Permit Issued

APPROVED BY: RNBrown
DATE: 01/25/2022
CASE NO.: B-21-0495
CONDITIONS:

PROJECT FOR PUYALLUP SCHOOL DISTRICT KESSLER CENTER 1501 39TH AVENUE SOUTHWEST PUYALLUP, WA 98373

B4.1 - NORTH VIEW **PROFILE VIEW** **B4.1 - SOUTH VIEW**

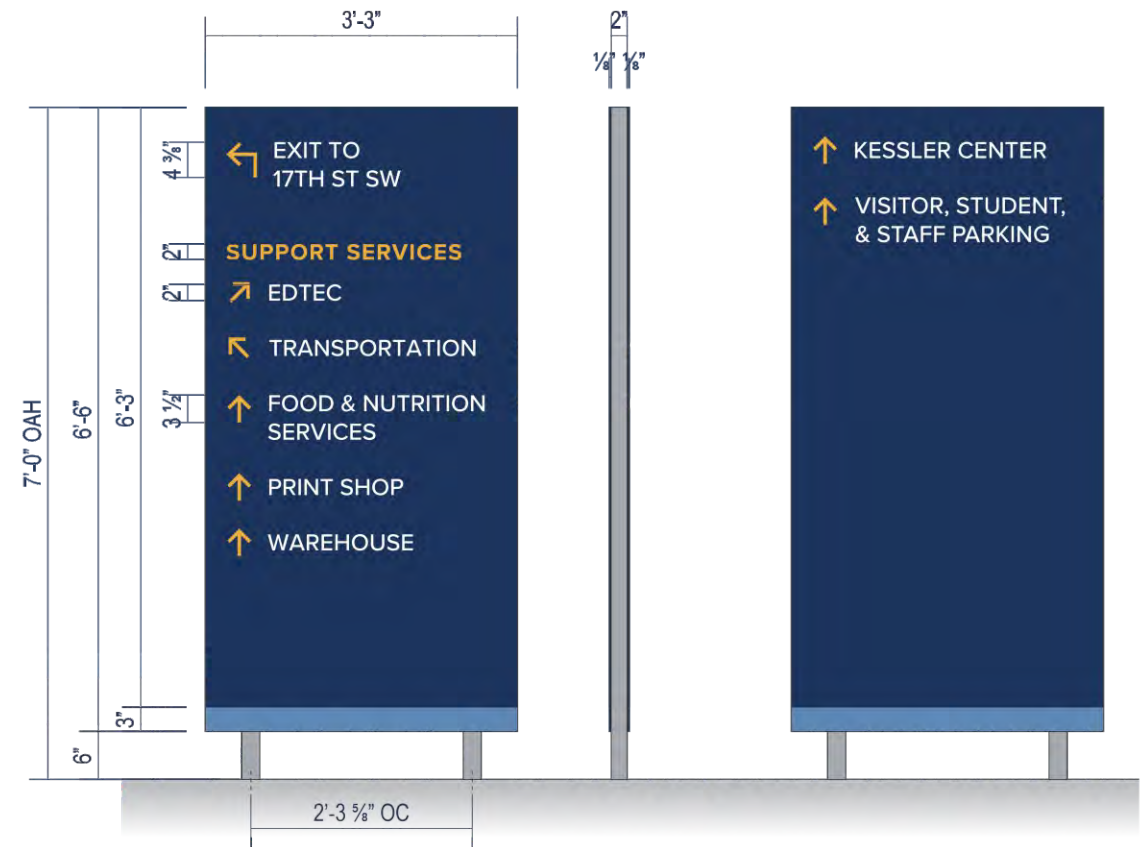
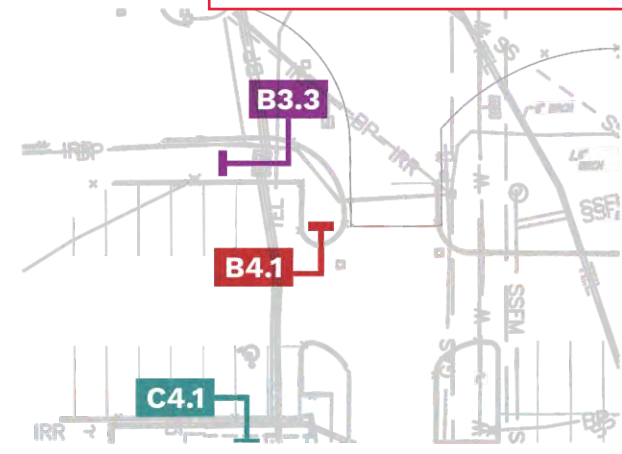
This footing needs to be dug with a vac truck.

B4.2 - NORTH VIEW **PROFILE VIEW** **B4.2 - SOUTH VIEW**

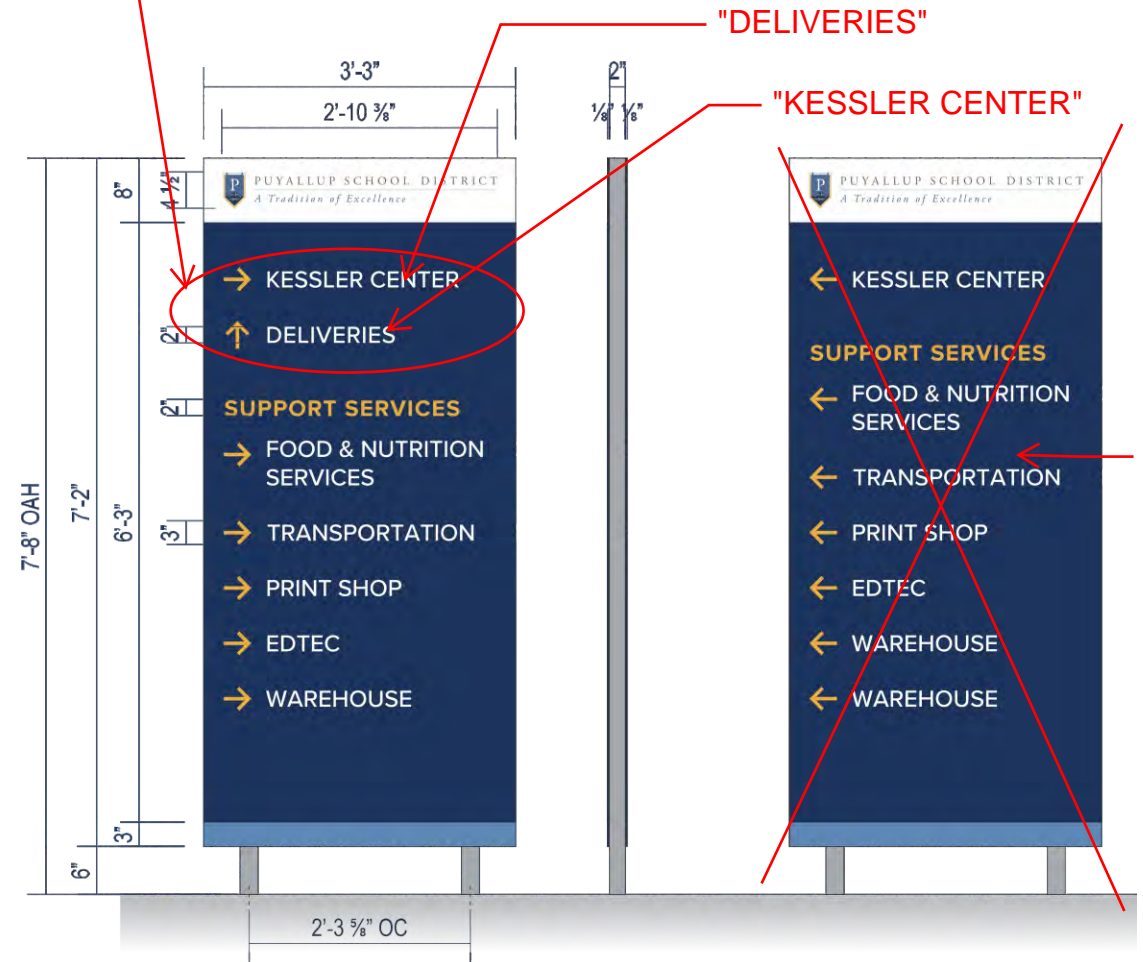
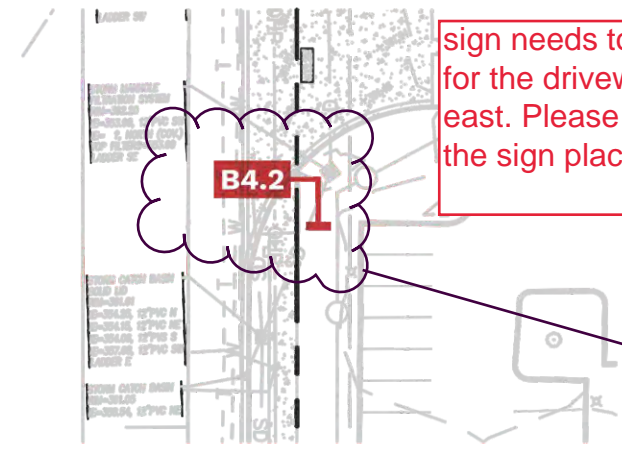
REVERSE VERBIAGE SO THAT "DELIVERIES" IS ON TOP AND "KESSLER CENTER" IS BELOW.

DELETE BACK SIDE OF SIGN

Incorrect sign location see approved sign location for sign B4.2 on Sheet 3 of 5, b-21-0495 resub 2 plans, Sheet 1 of 5.

C2.1 CONFORMED SET

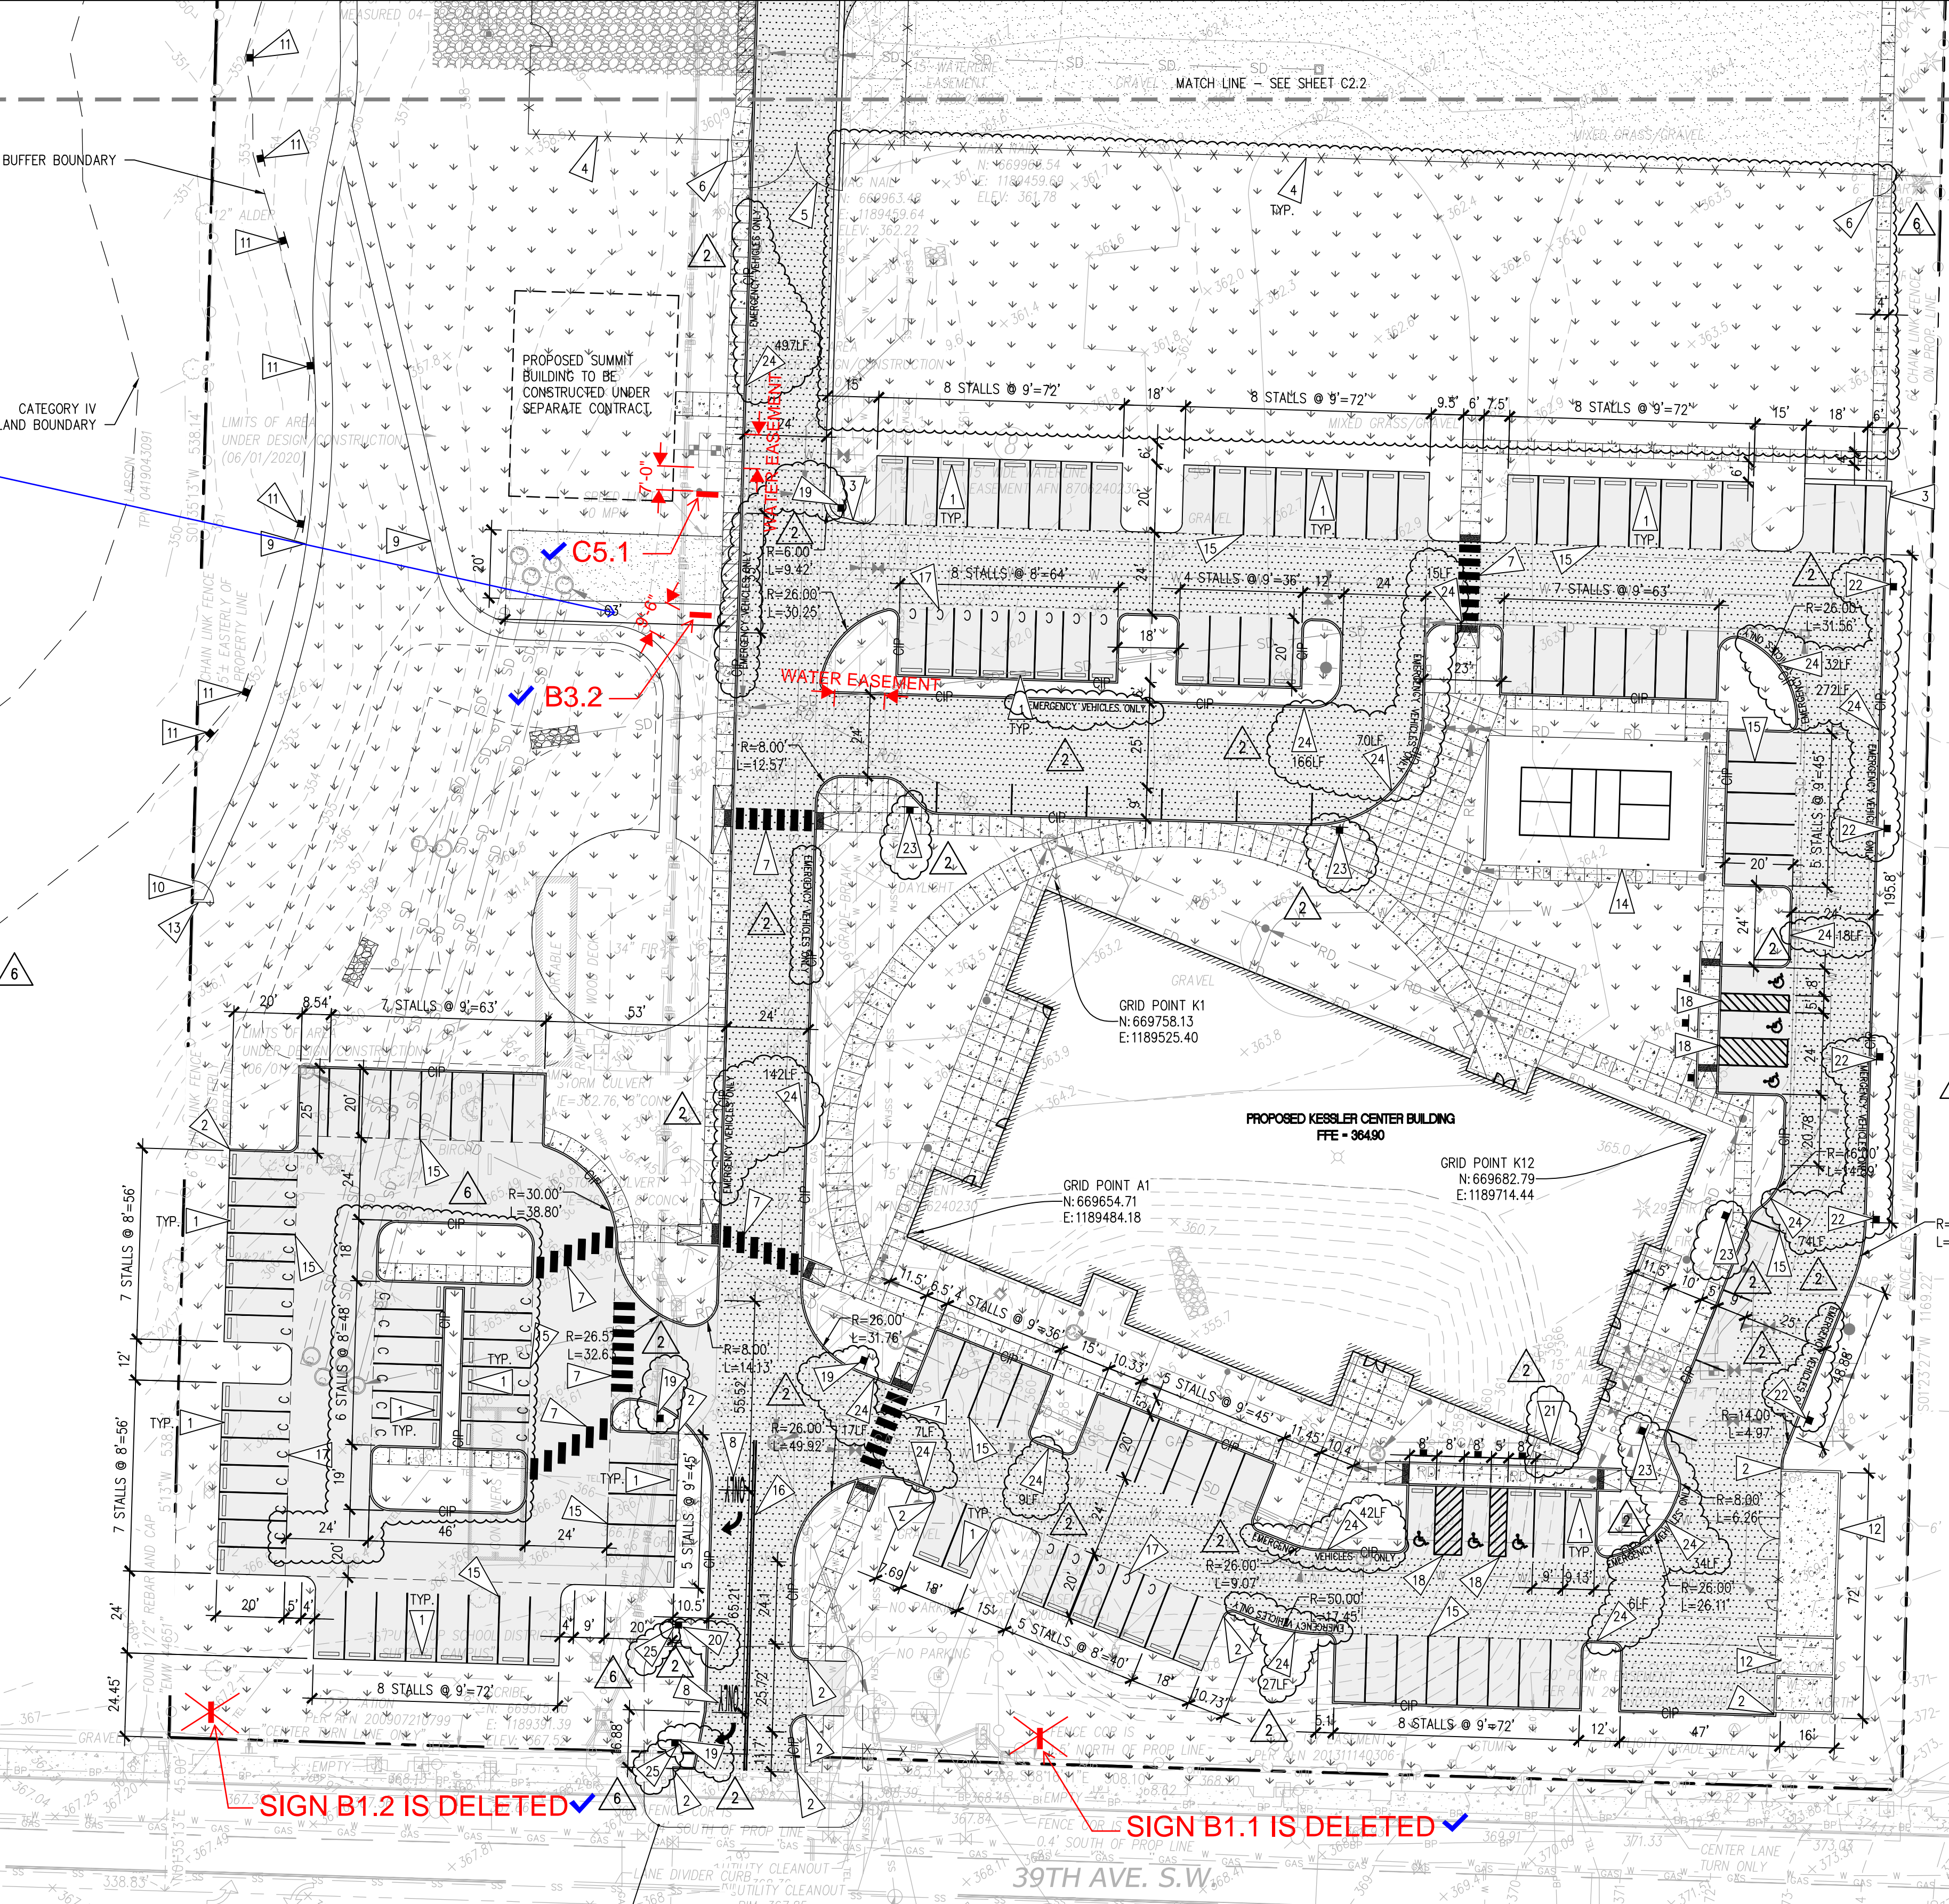
B3.2 shall be installed at least 9'6" from underground roof drain line as indicated on plans.
